From: Anna Kramarczyk <Anna.Kramarczyk@midsussex.gov.uk>
Sent: 16 July 2025 17:37:39 UTC+01:00
To: "Joseph Swift" <Joseph.Swift@midsussex.gov.uk>; "Sally Blomfield" <Sally.Blomfield@midsussex.gov.uk>
Subject: Signage COOS condition 11
Attachments: signage.pdf

I had a look at the signage strategy; I have only two points to add.

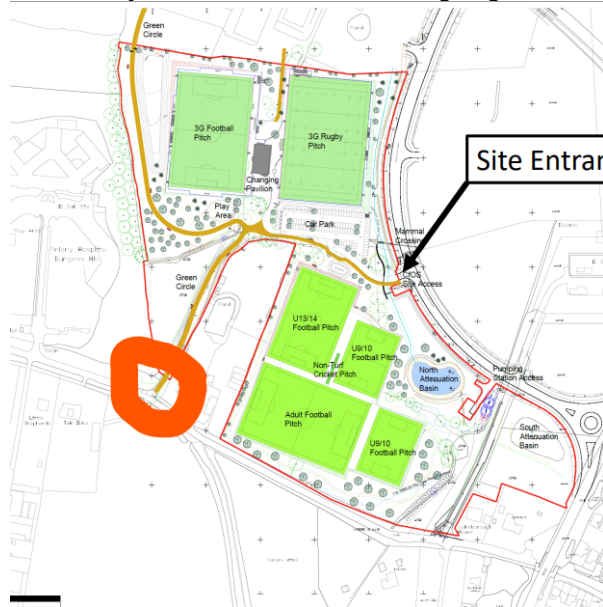
- I understand the idea of keeping the main colours consistent with MSDC (blue and white). However, in my opinion it would be more suitable to remove the blue altogether and replace it with black. Blue doesn't align with the contemporary tone and high level of detail present throughout the site. A more restrained colour palette—one that reflects expectations within a landscape context—would be far more appropriate.
- Also like you mentioned, some signage would be needed to this entrance

- Furthermore, as discussed on site with Sally , there is no need for the elevation facing the pitches to have more clutter, and signage there would be better removed.
